Pau Hara Elderly Housing

96/SMA-033(ASK) 96/SV-003(ASK) 96-07733

Chapter 343, Hawaii Revised Statutes Environmental Assessment/Determination Finding of No Significant Impact

Environmental Assessment
Application for Special Management Area (SMA) Use Permit
Application for Shoreline Setback Variance

Figure 2-6

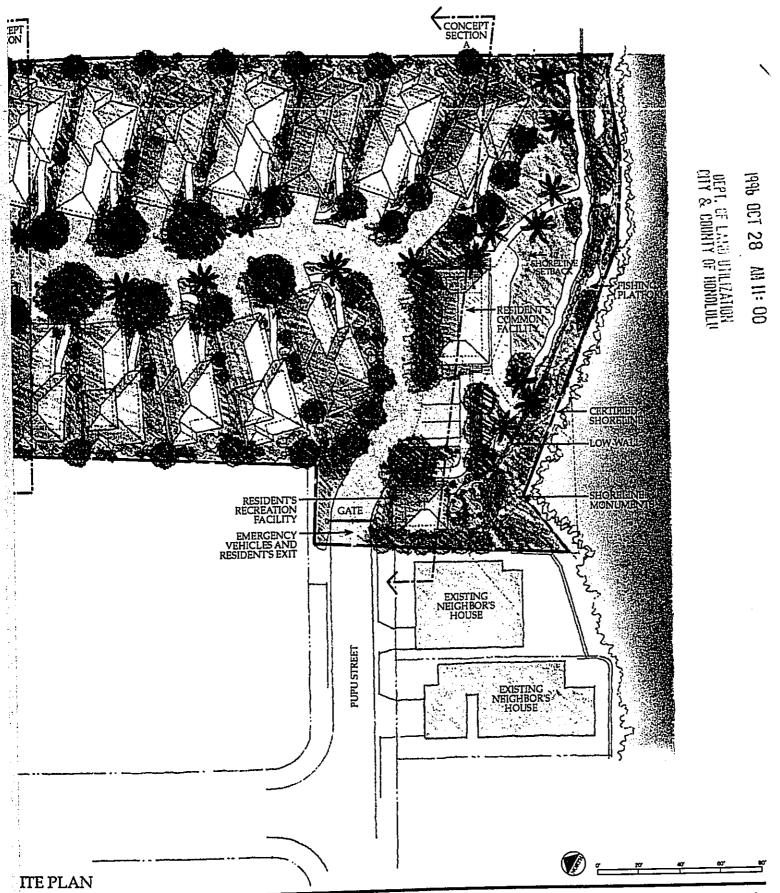
The FEA should clearly describe and justify all of the structures within the 40-foot shoreline setback area. Figure 2-6 seems to portray landscaping makai of the CRM wall. Is the installation of top soil, irrigation and landscaping proposed in this area? Side yard walls and fences should be described. Provide a physical description of the shoreline monuments and their purpose.

The property boundary should be labeled on the site plan.
